# AUSPLOW FARMING SYSTEMS

## **PARTS BULLETIN No. 6-15**

**01-04-15**

**Subject: NEW PART - SINGLE HUMP COUPLER P/N 27288 / 27289**

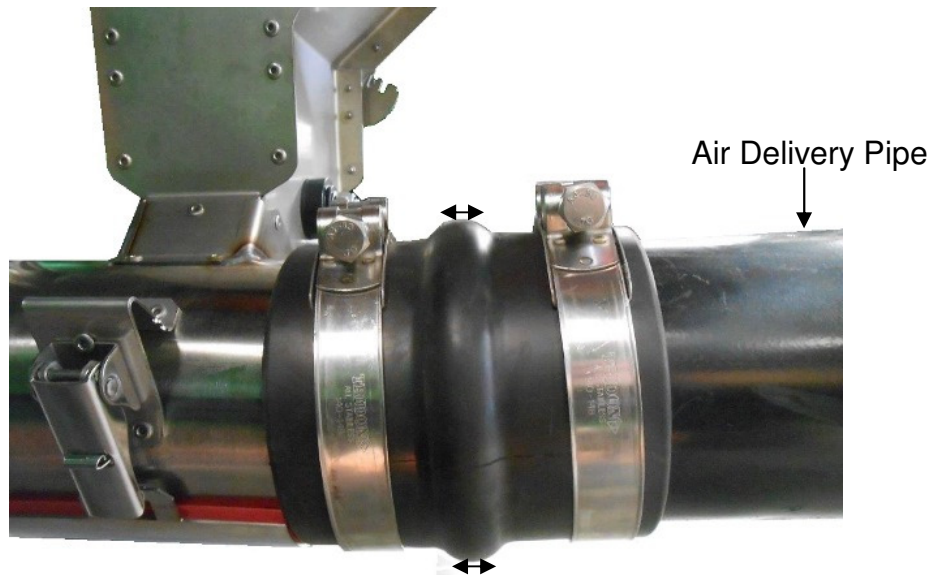
From March 2015 all new Ausplow Multistream air delivery hose kits will now be supplied with a new design joiner (single hump coupler) to help reduce potential air leaks, and provide increased serviceability.

**Single Hump Coupler 127mm EDPM Part Number 27288** is a direct replacement for 5" butt clamp P/N 09703, however requires two additional T-bolt hose clamps P/N 09744.

**Single Hump Coupler 152mm EDPM Part Number 27289** is a direct replacement for 6" butt clamp P/N 09644, and also requires two additional T-bolt hose clamps P/N 09512.

Ausplow recommends trimming the steel air delivery pipe to create a 20mm gap between air pipes to provide proper fitment of the coupler.

**27288 Single Hump Coupler 127mm EDPM**  
09744 Hose Clamp T-Bolt 131-139 SS

**27289 Single Hump Coupler 152mm EDPM**  
09512 Hose Clamp - T-Bolt -162-174SS
